RENESAS TECHNICAL UPDATE

Product Category	MPU/MCU		Document No.	TN-RX*-091A/E	Rev.	1.00
Title	Corrections to the RX111 Group User's Manual: Hardware regarding Communication Protocol of the Flash Memory		Information Category	Technical Notification		
Applicable Product	RX111 Group	Lot No.	Reference Document	RX111 Group User's Manual: Hardware Rev.1.00 (R01UH0365EJ0100)		
		All

This document describes corrections to descriptions for communication protocol of the flash memory in RX111 Group User's Manual: Hardware.

Figure 35.16 Procedure to Select the Device and Change the Bit Rate is corrected as follows:

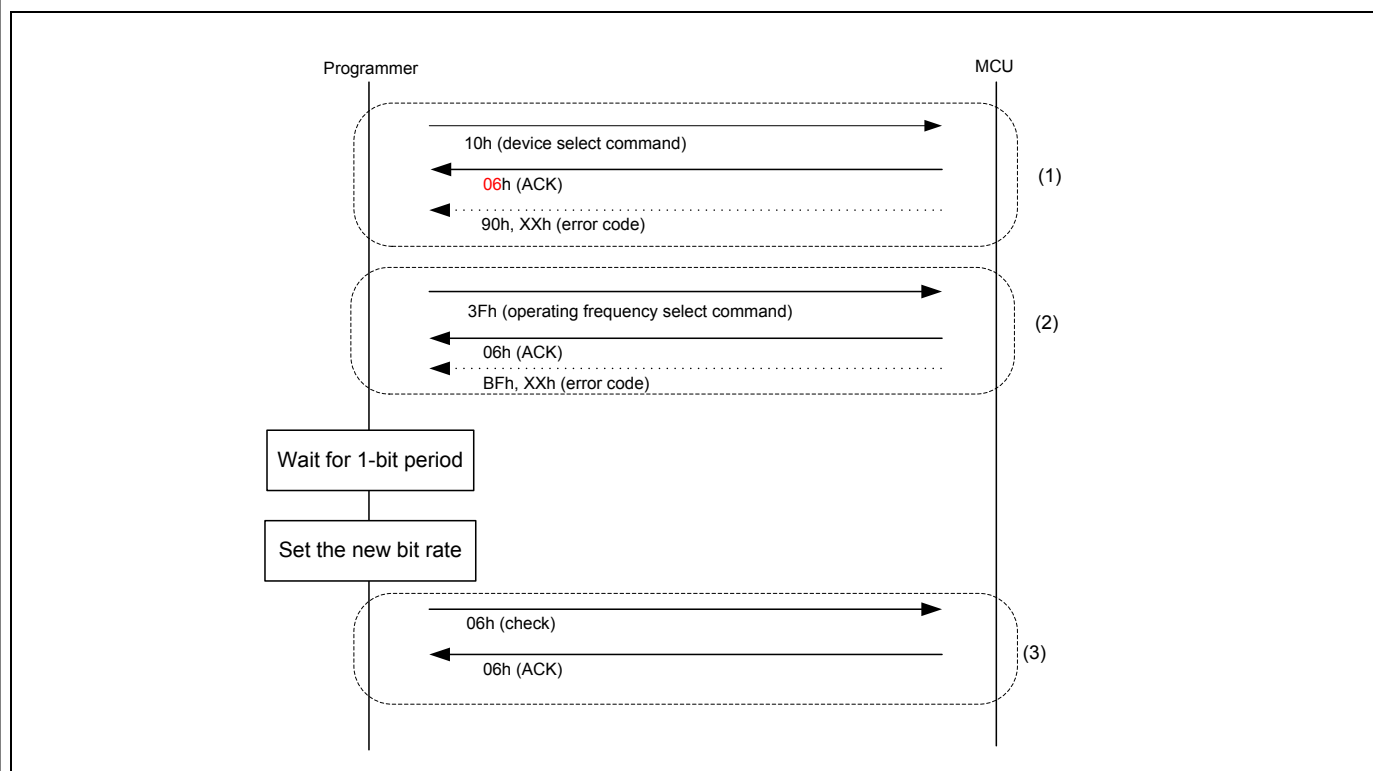
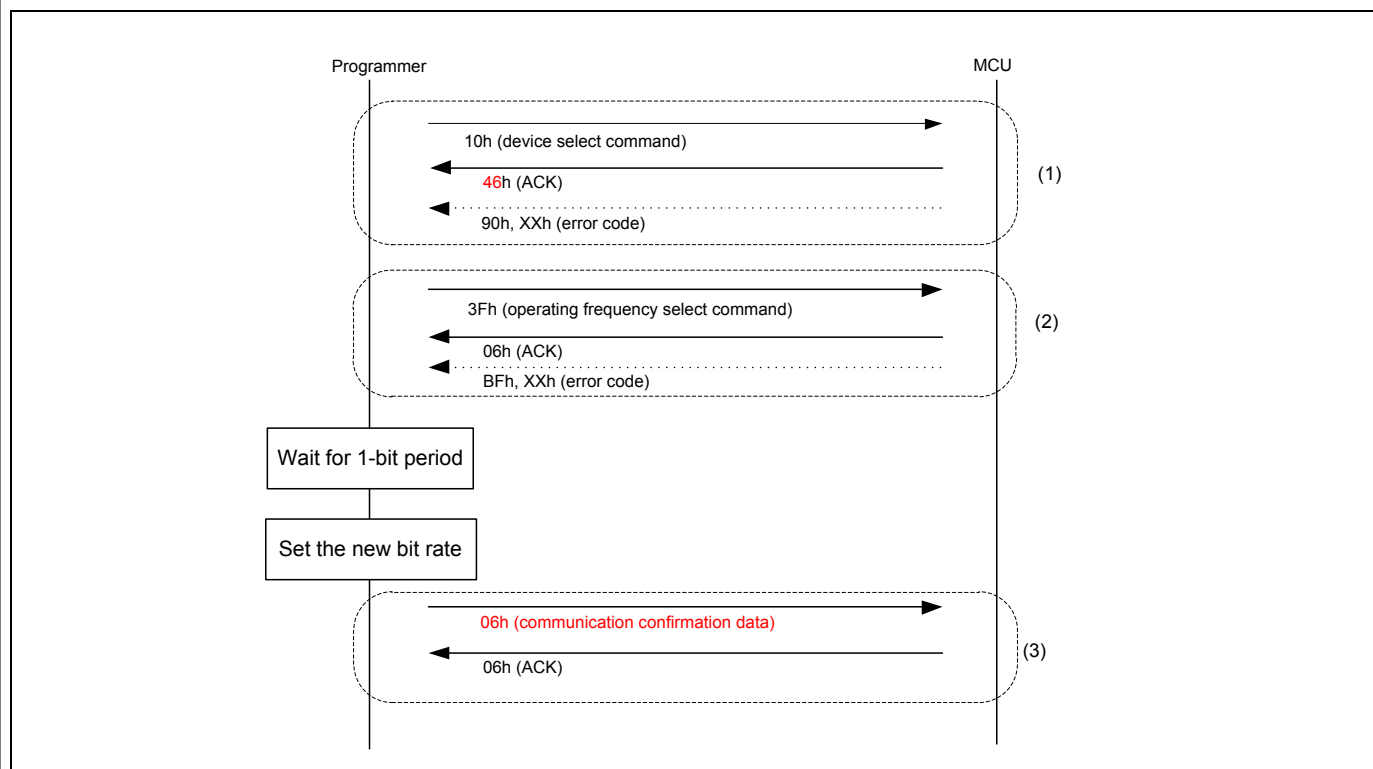
- (1) Send the device select command (10h) to select the device to connect with the programmer and the endian of data that is programmed. When the program data is little endian, select the same device code as that for little endian in the response to the support device inquiry command. When the program data is big endian, select the same device code as that for big endian in the response to the support device inquiry command. When the device is selected successfully, the MCU sends a response (06h). When the MCU fails to receive, the MCU sends an error response (90h).

- (2) Send the operating frequency select command (3Fh) to change the bit rate for communication. When the bit rate is set successfully, the MCU sends a response (06h). When the bit rate cannot be changed, or when the MCU fails to receive, the MCU sends an error response (BFh).

- (3) When **the MCU** receives a response (06h), the MCU waits for 1-bit period at the bit rate for sending the operating frequency select command, and then set the bit rate of the programmer to the changed value. After that, the MCU sends communication confirmation data (06h) at the changed bit rate. When the MCU receives the command successfully, the MCU sends a response (06h) of the communication confirmation data.

- (1) Send the device select command (10h) to select the device to connect with the programmer and the endian of data that is programmed. When the program data is little endian, select the same device code as that for little endian in the response to the support device inquiry command. When the program data is big endian, select the same device code as that for big endian in the response to the support device inquiry command. When the device is selected successfully, the MCU sends a response (46h). When the MCU fails to receive, the MCU sends an error response (90h).

- (2) Send the operating frequency select command (3Fh) to change the bit rate for communication. When the bit rate is set successfully, the MCU sends a response (06h). When the bit rate cannot be changed, or when the MCU fails to receive, the MCU sends an error response (BFh).

- (3) When **the programmer** receives a response (06h), the MCU waits for 1-bit period at the bit rate for sending the operating frequency select command, and then set the bit rate of the programmer to the changed value. After that, the MCU sends communication confirmation data (06h) at the changed bit rate. When the MCU receives the command successfully, the MCU sends a response (06h) of the communication confirmation data.

Figure 35.19 Procedure to Send Commands in Erase Ready Operation is corrected as follows:

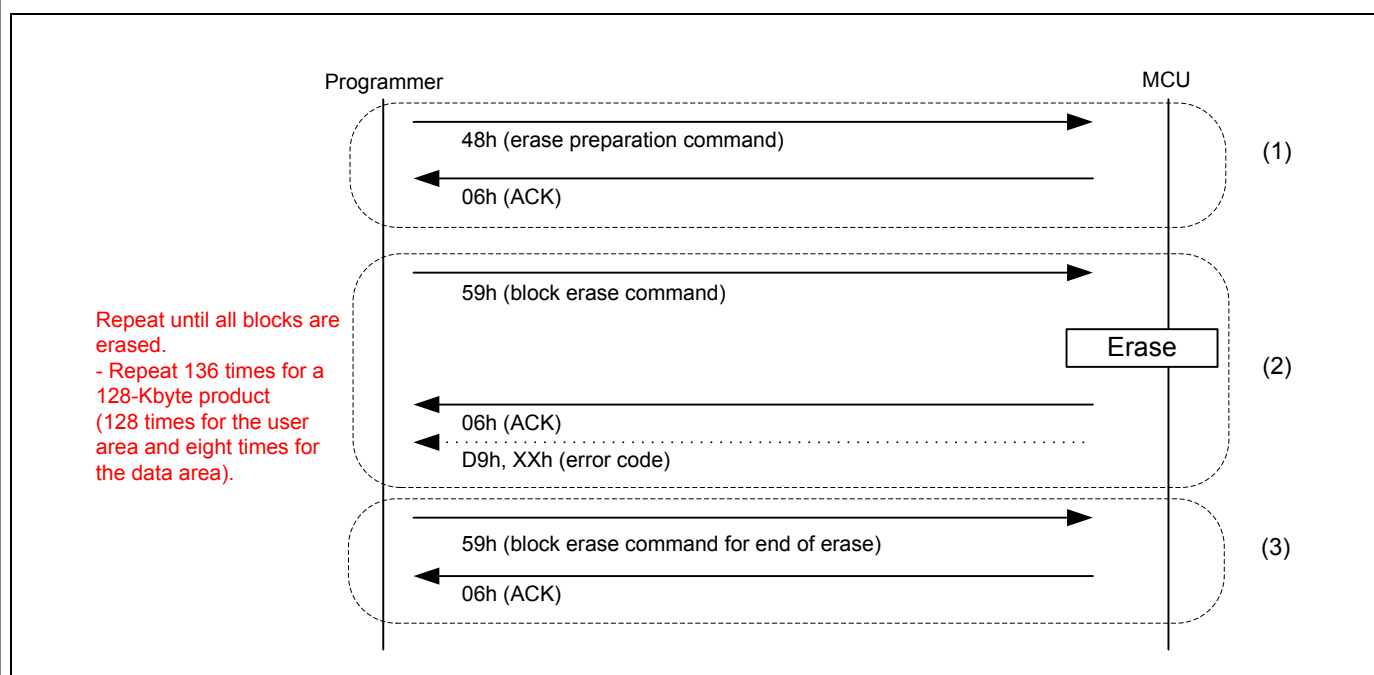
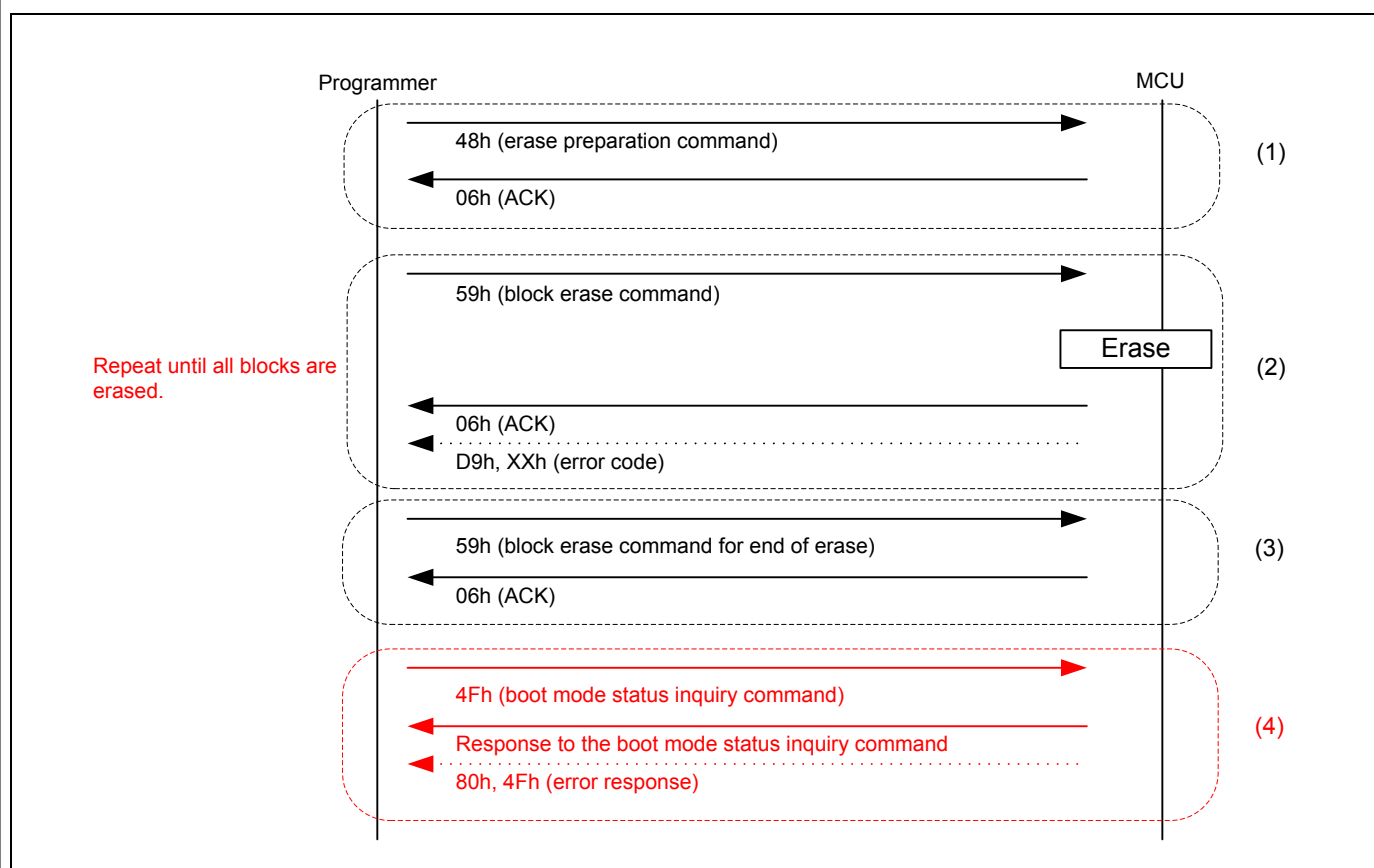
(1) Send the erase preparation command (48h) to place the MCU in the erase wait state. The MCU enters the erase wait state and sends a response (06h).

(2) Send a block erase command (59h) to erase blocks in the MCU. When blocks are erased successfully, the MCU sends a response (06h). When the MCU fails to receive, the MCU sends an error response (D9h).

Send a block erase command repeatedly until block erase commands for all blocks are sent. When the operation ends before all the block erase commands are sent, a command error may occur even when a correct command is sent in the program/erase state.

(3) In order to place the MCU in the program/erase state, send a block erase command for end of erase (59h 04h FFh FFh FFh FFh A7h). The MCU enters the program/erase state and sends a response (06h).

(1) Send the erase preparation command (48h) to place the MCU in the erase wait state. The MCU enters the erase wait state and sends a response (06h).

(2) Send a block erase command (59h) to erase blocks in the MCU. When blocks are erased successfully, the MCU sends a response (06h). When the MCU fails to receive, the MCU sends an error response (D9h).

Send block erase commands repeatedly until a block erase command has been sent for the total number of blocks.

The total number of blocks is the sum of the user area blocks and data area blocks that are obtained in advance using the block information inquiry command. If the operation ends before all the block erase commands are sent, a command error may occur even when a correct command is sent in the program/erase state.

(3) Send a block erase command for end of erase (59h 04h FFh FFh FFh FFh A7h). The MCU sends a response (06h).

(4) To confirm whether erase ready operation has ended, send a boot mode status inquiry command (4Fh). When the erase ready operation has ended, the MCU returns the result of the boot mode status inquiry. When the erase ready operation has not ended, the MCU sends an error response (80h 4Fh). When an error response is received, restart the MCU in boot mode and perform the procedure again from section 35.9.10.1, Bit Rate Automatic Adjustment Procedure.
